**Re: Response to Comments  
90% Design – Slip 3 Containment Alterations  
OMC Superfund Site, Waukegan, Illinois**

## CONTAINMENT ALTERATION / BOAT STORAGE RE-USE

### WAUKEGAN HARBOR SLIP 3 SITE

100% DESIGN SUBMITTAL  
OCTOBER 2007

SLIP 3  
CONTAINMENT ALTERATIONS / BOAT STORAGE  
DETAILS 1 to 7  
PREPARED FOR  
CITY OF WAUKEGAN

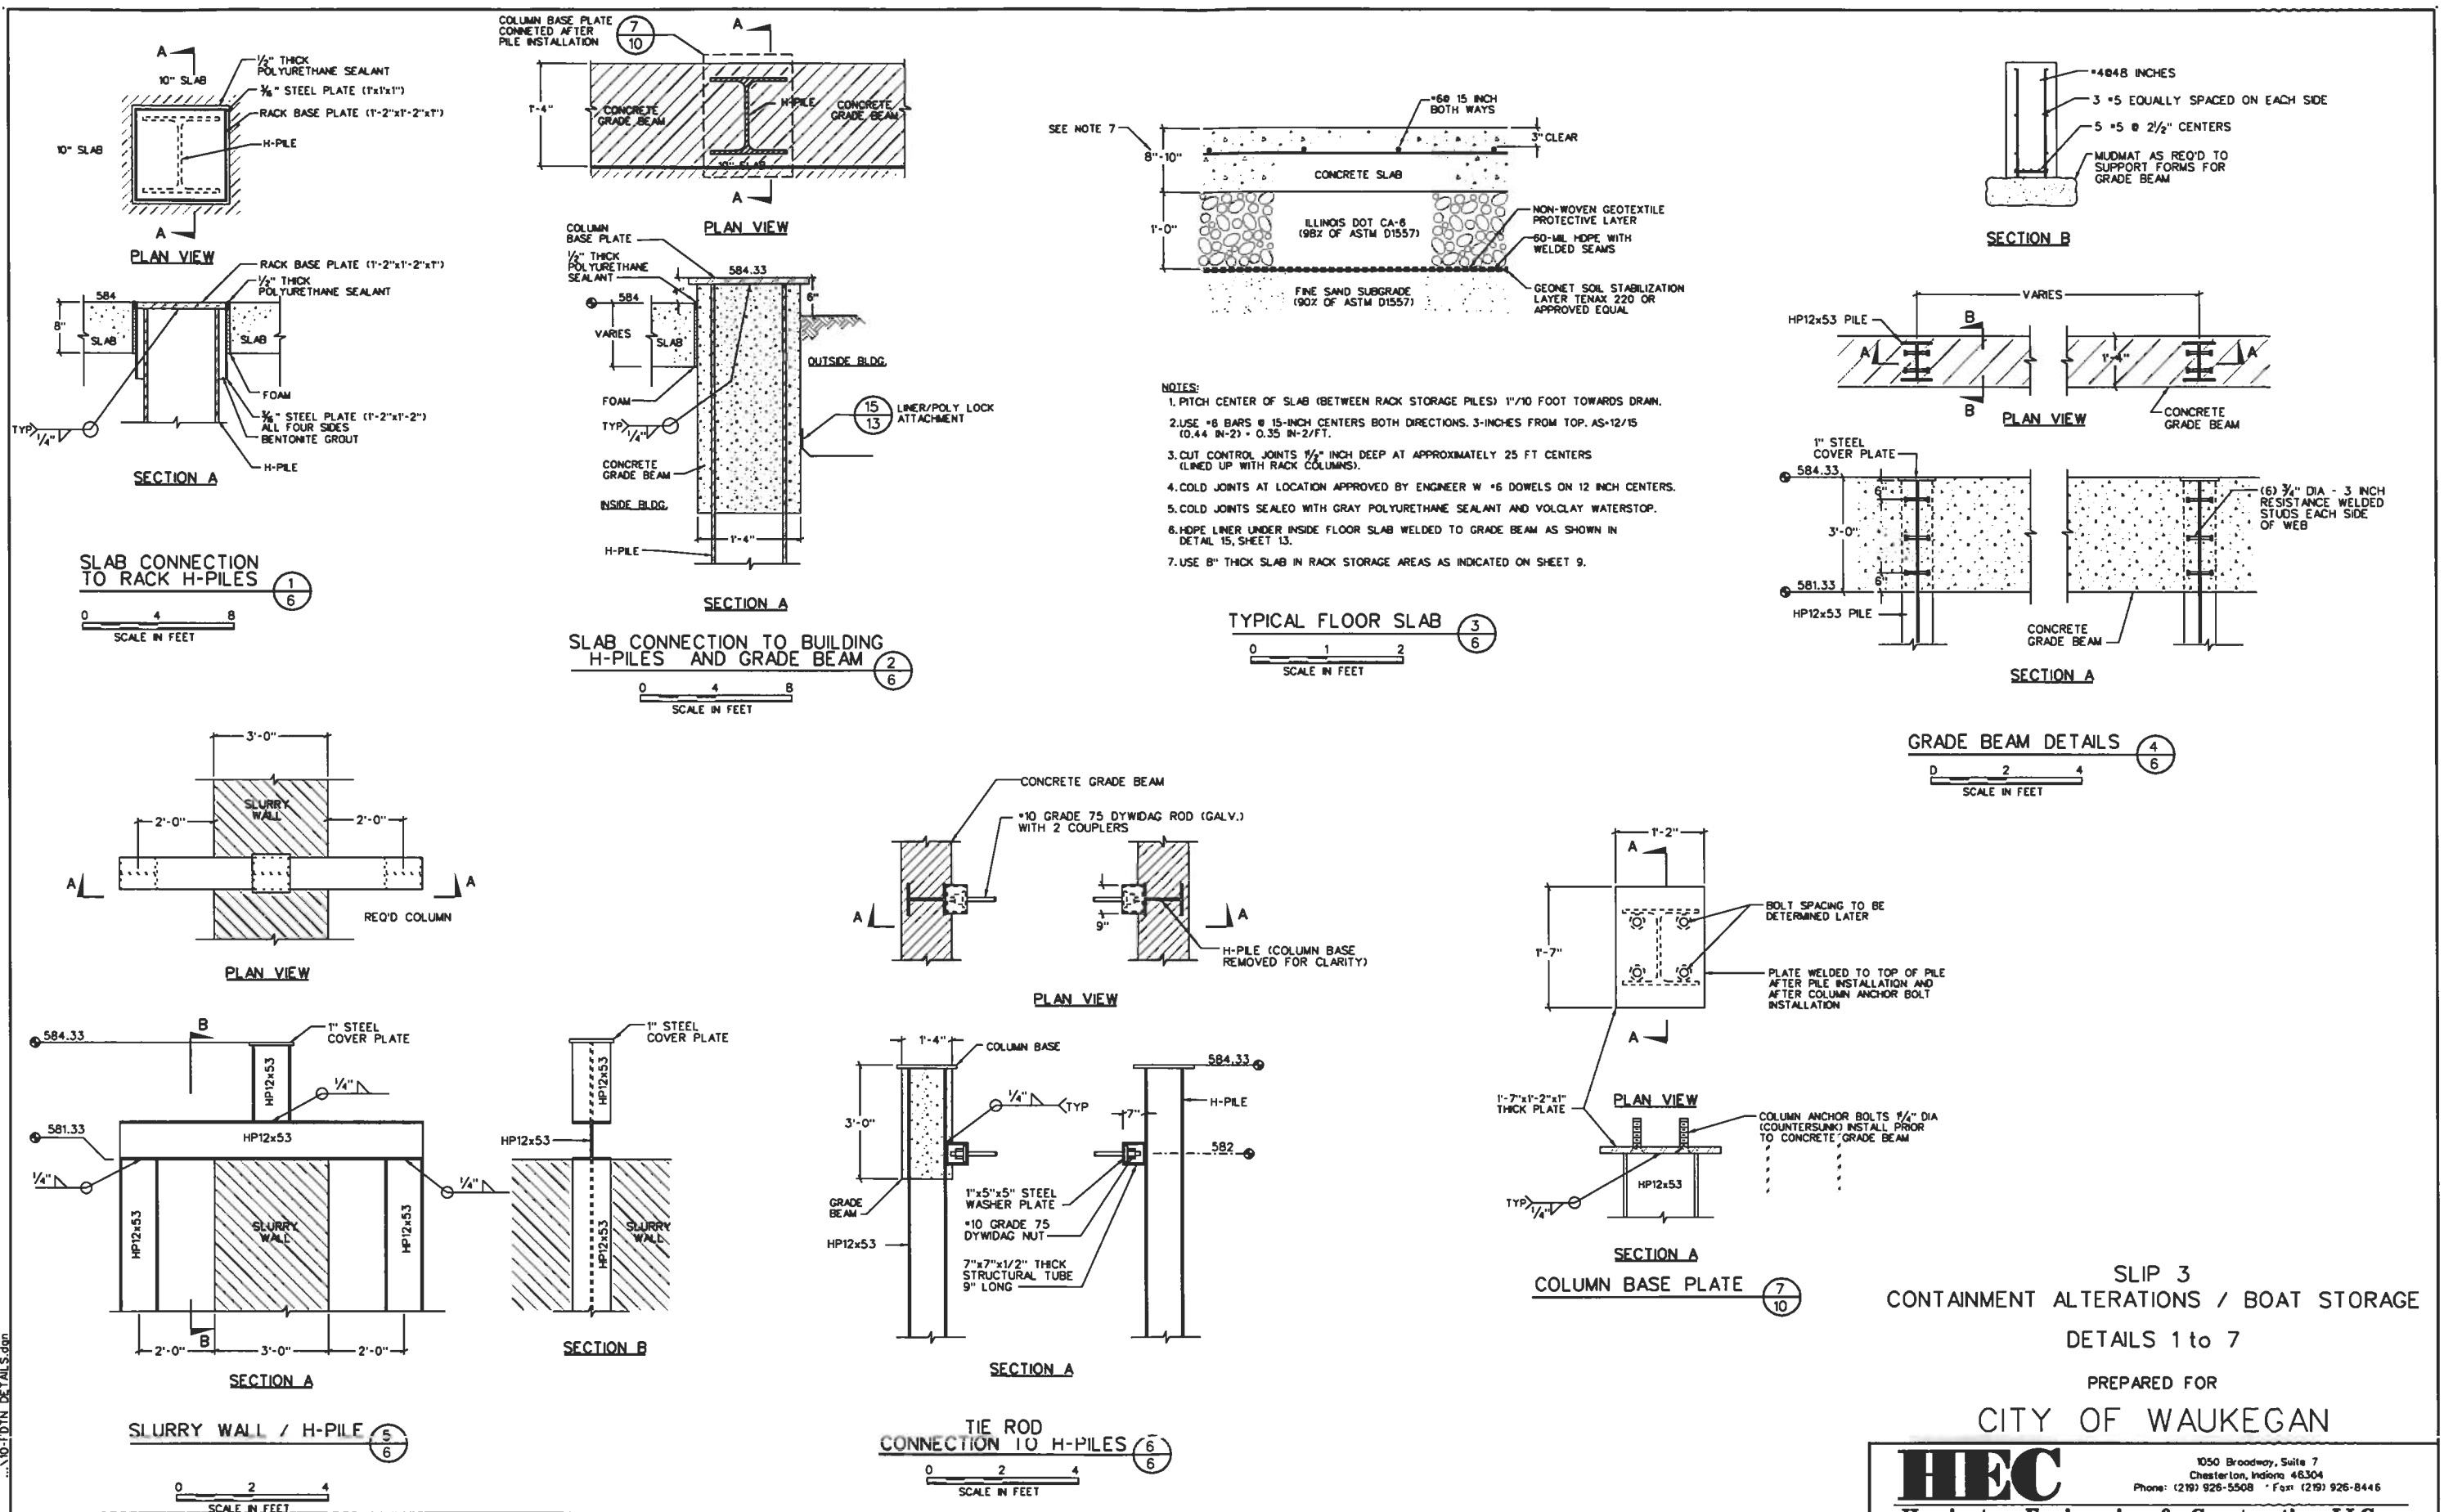
3. **Sheet 10. Detail 3. Note 6.** *This states that the HDPE liner under the interior floor slab is not welded to the grade beam. It should be to provide a continuous primary lining.*

Note 6 will be revised to state that the liner shall be welded to the grade beam using a Polylock imbed on the inside of the grade beam with the detail as shown in the Polylock detail (Detail 15 on Sheet 13). This will allow the liner to perform its function as a secondary containment barrier to water intrusion and to act as a barrier to vapor from inside the containment.

SLIP 3  
CONTAINMENT ALTERATIONS / BOAT STORAGE  
DETAILS 8 to 12  
PREPARED FOR  
CITY OF WAUKEGAN

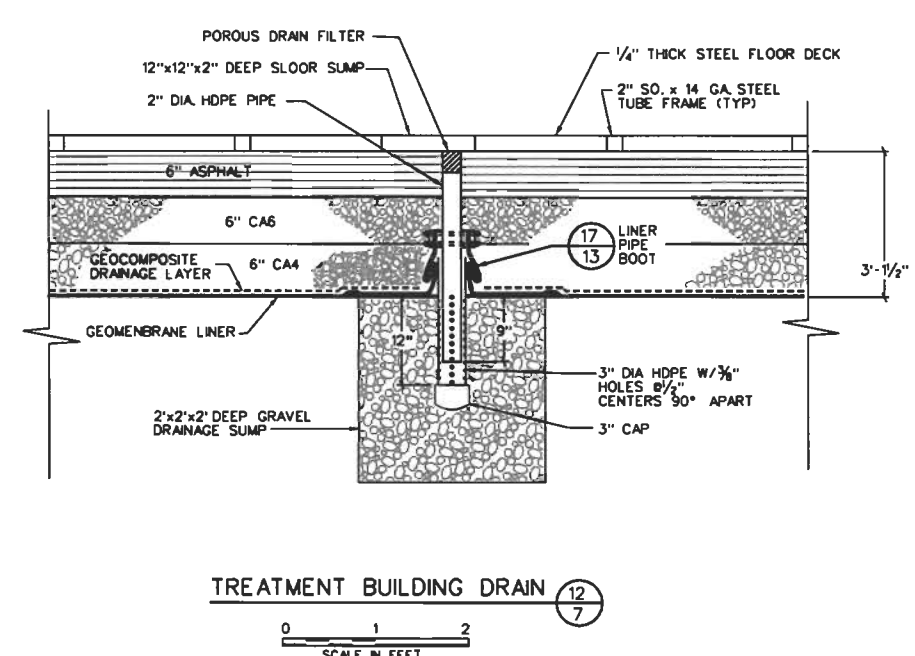
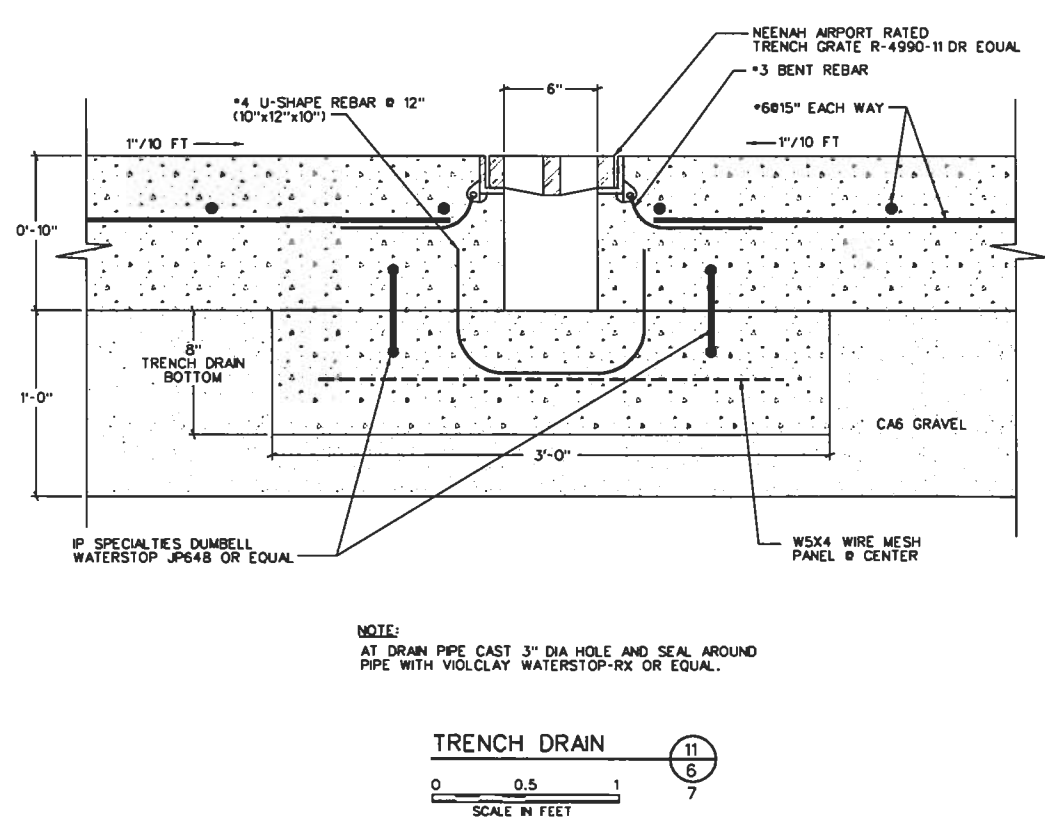
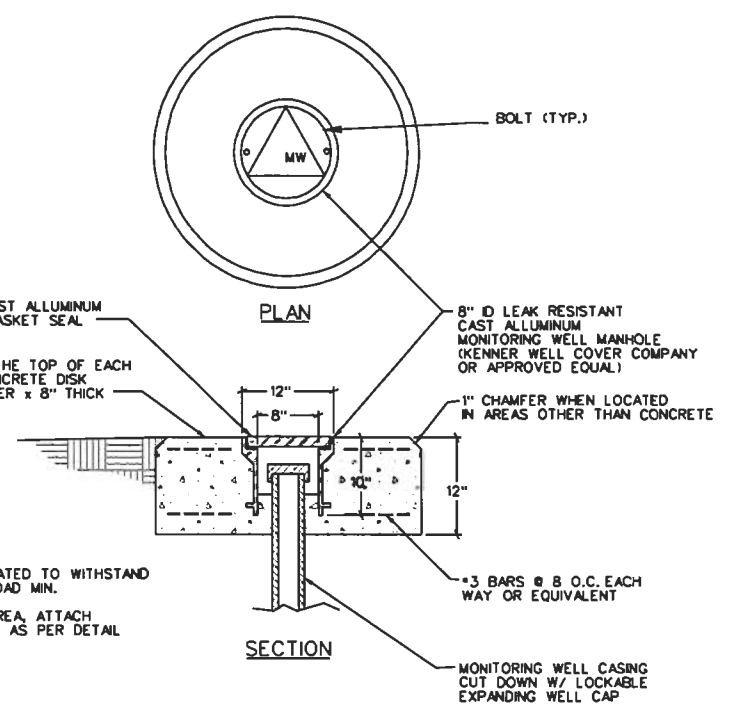
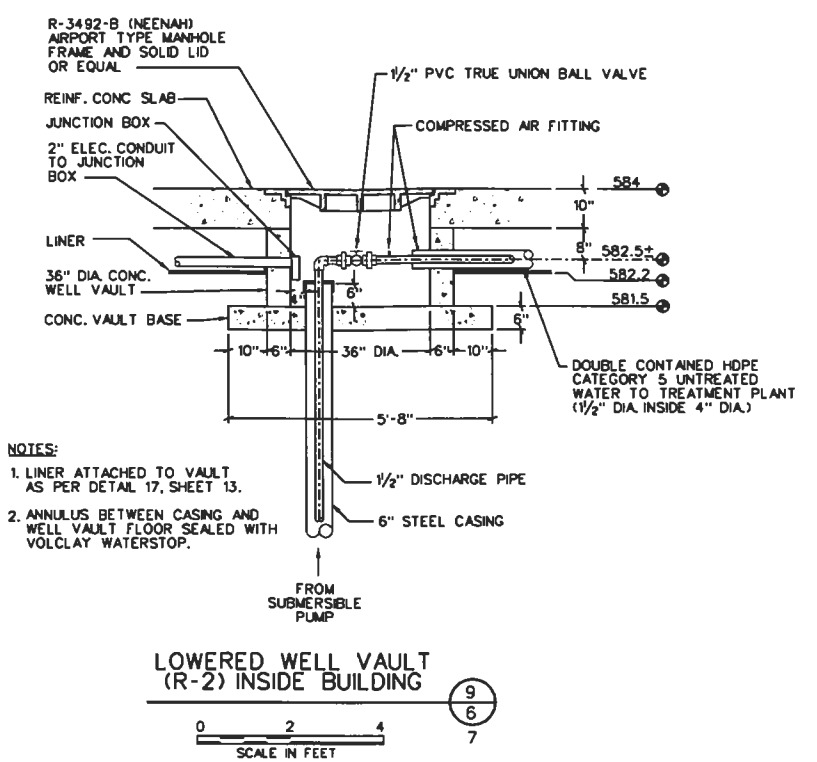
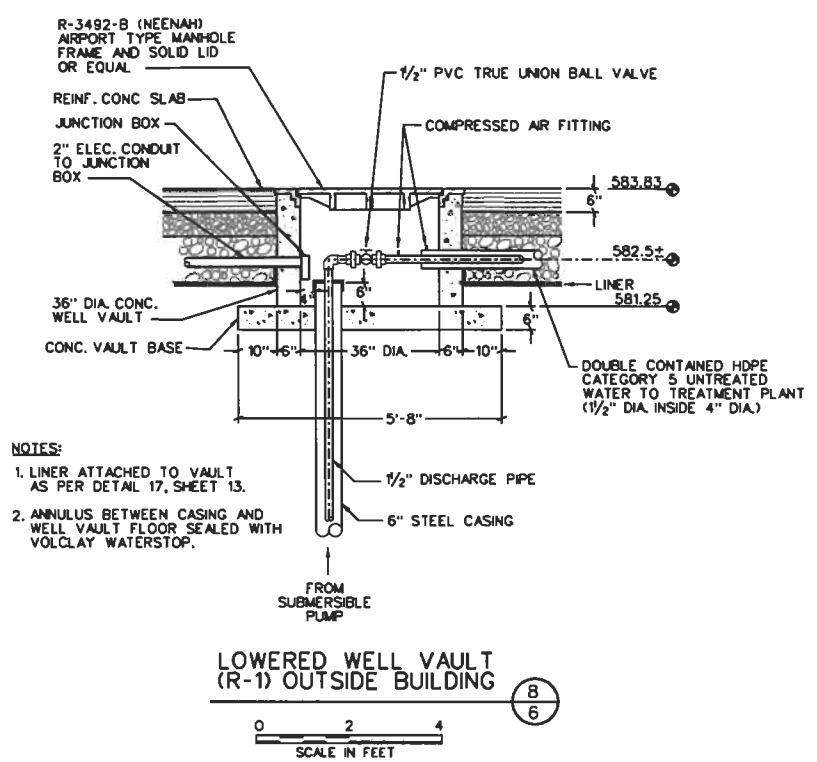
4. **Sheet 11. Detail 7.** *The lowered Well Vault (R-1) is not called out on Sheet 6. Should this be Detail 8 (on Sheet 7)? In addition, the liner to well vault penetration detail (Detail 17 on Sheet 13) should be called out to show how the HDPE will be connected to the vault to provide a continuous primary lining.*

5. **Sheet 11. Detail 9.** *How is the HDPE connected to the steel casing to provide a continuous primary lining?*

6. **Sheet 11. Detail 10.** *It is not clear where this detail applies. If within the building, how is the HDPE connected to the concrete to provide a continuous primary lining?*

Sheet 6 of 13 shows only the building and does not include the area of lowered Well Vault (R-1). The location of R-1 is shown on Sheet 7 of 13 and Detail 7 on Sheet 11 should be labeled as Detail 8 and is changed. A note for this detail is also added to refer to the liner penetration detail 17/13 as the means of attaching the liner to the well vaults at both R-1 and R-2.

Detail 9 is revised to show the HDPE liner connected to the well vault body at elevation 582.2 feet. A note is also added to indicate that the annulus between the steel casing and the base of the R-1 and R-2 well vault will be sealed with the volclay waterstop specified on Sheet 10 of 13. There will not be a connection of the HDPE liner with the steel casing of the recovery well.

This detail applies to the monitoring wells located within the slurry wall footprint that are shown on Sheet 2 (none are located within the building footprint). A note is added to Sheet 2 to indicate revision from above grade covers to the detail 10 of Sheet 11 detail. Continuous primary lining will attach to the riser pipe as shown in Detail 17. A note is added to Sheet 11 to clarify liner attachment where liner is present (The "W" wells are outside of the slurry wall and will not need to have the liner attached to the well casing).

SLIP 3  
CONTAINMENT ALTERATIONS / BOAT STORAGE  
DETAILS 13 & 14

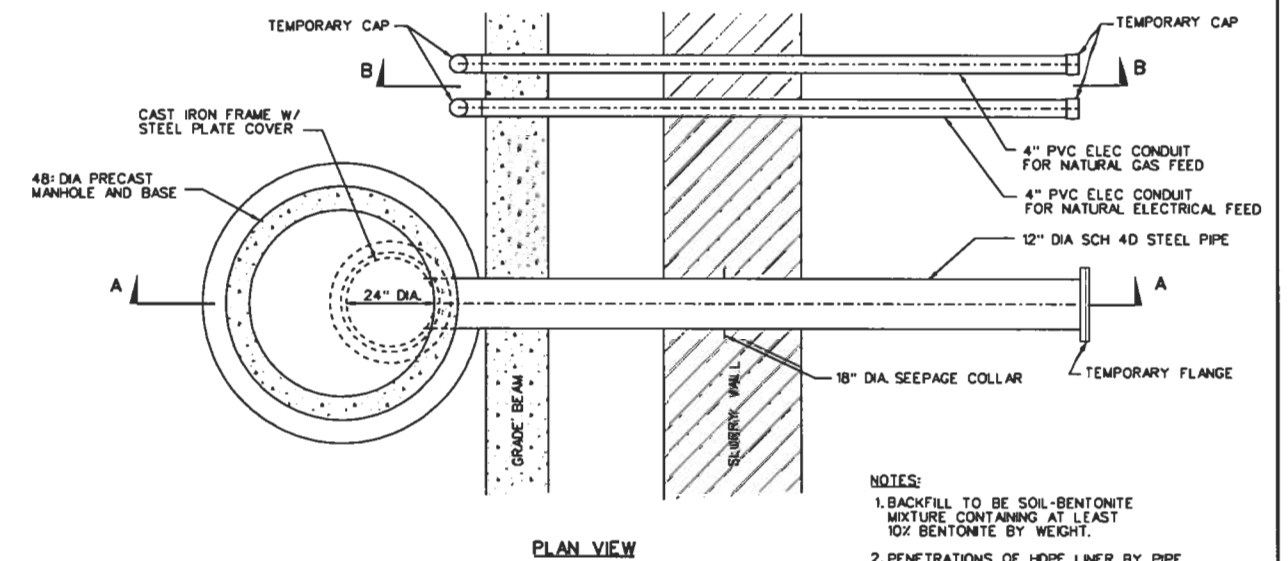
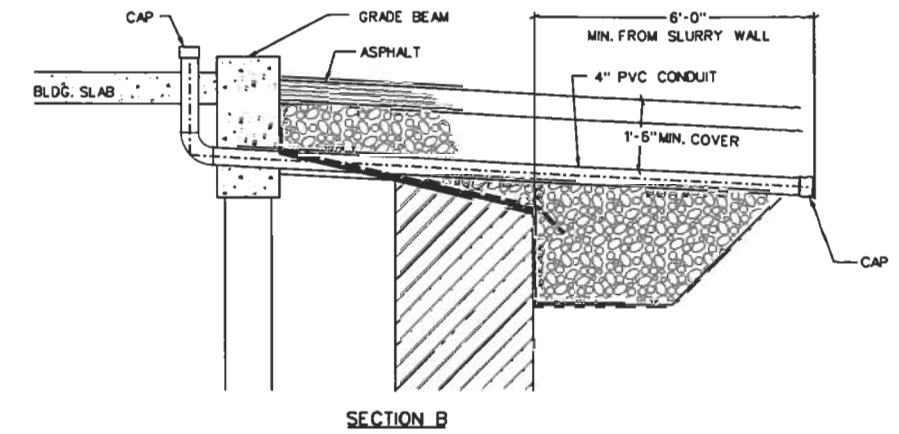
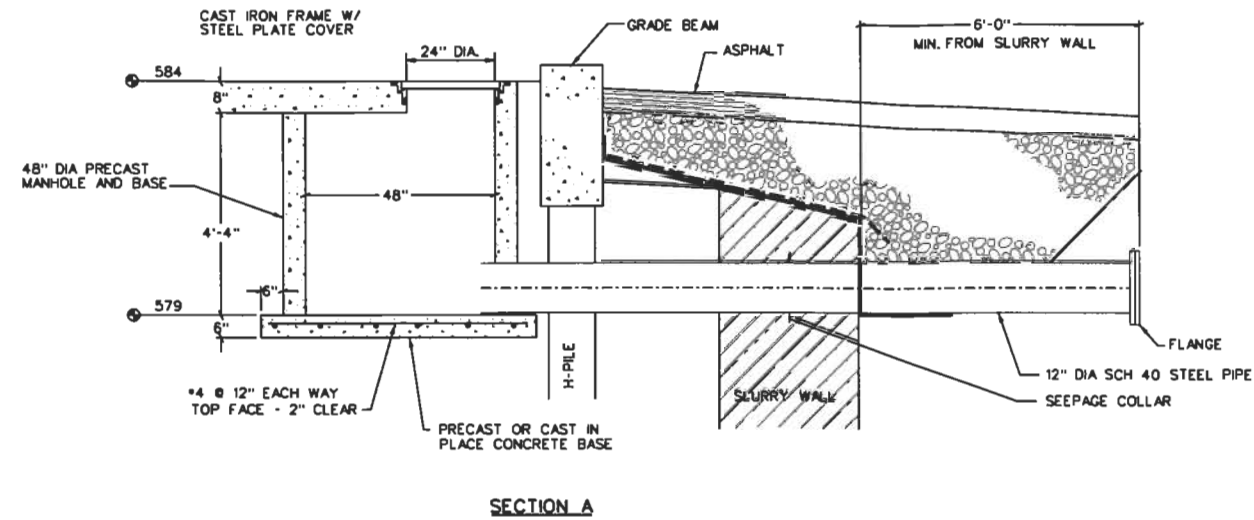
- a. *Special care will have to be taken to protect the HDPE liner from potential puncture damage where it crosses the slurry wall; the specifications should discuss removal of rocks or other objects as needed to protect the liner here.*
- b. *In Section B, provide a boot-type penetration for both conduits (or some other method to provide a continuous primary lining).*
- c. *In Section A and the plan view, the specifications should discuss how the 12-inch-diameter steel pipe is placed to minimize the potential for void formation in the slurry wall backfill. The seep collar is a good idea; the specifications should call for careful tamping of the backfill around the collar and beneath the pipe.*

All penetrations of the liner will be as shown in Detail 17. The title of that detail will be changed to reflect the intent that it should apply to all penetrations and a note referencing the detail is added to Section B on Sheet 12 of 13.

Installation notes requiring that the backfill be replaced with soil bentonite mixture containing at least 10% bentonite by weight is added to the steel pipe Detail 13.

POLY LOCK ATTACHMENT  
NTS

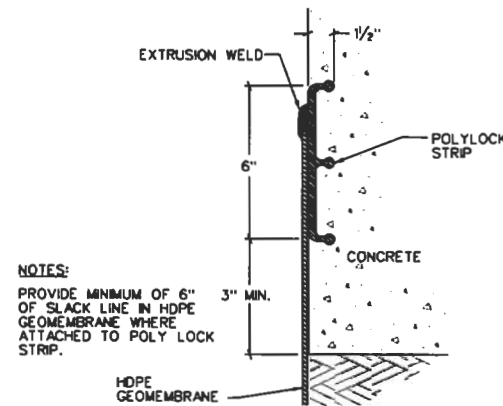
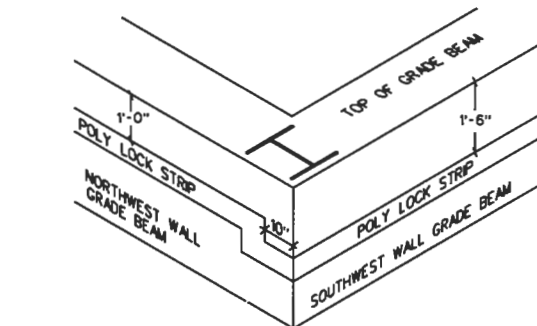
- 8. Sheet 13. Detail 15.** *The use of the Polylock strip is a convenient method to connect to the concrete, but has limited structural strength. Provision should be made to provide some amount of slack in the liner, or to otherwise accommodate potential differential settlement between the soil and the grade beam. The grade beams are pile-supported and therefore unlikely to settle very much, while the fill is not pile-supported and may settle differentially relative to the grade beams.*

Detail 15 is revised to show slack in the liner as is shown on detail 17.

GENERAL DETAIL OF  
LINER PENETRATION -  
CIRCULAR PENETRATIONS  
NTS

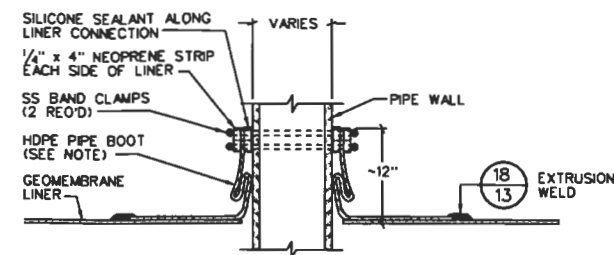
- 1. The basic concepts presented in the drawings appear to be reasonable, assuming that the characterization of the contamination provided in the TM is accurate. We have very few comments on the submittal; most relate to the need to provide details such that the new 60-mil HDPE lining – together with the other structural elements such as the grade beams – will provide a continuous primary containment barrier. Specifically, the drawings provide no detail regarding attachment of the HDPE lining to the various penetrations under the building (e.g., monitoring well, piling, etc.). It is unclear how the HDPE lining will act as a continuous primary containment without such connections.*

Responses to comments about individual penetrations are provided below. In general, any penetration of the liner by a circular object will be as shown in detail 17 on Sheet 13 of the Drawings. The title of this detail is changed to General Detail of Liner Penetration – Circular Penetrations.
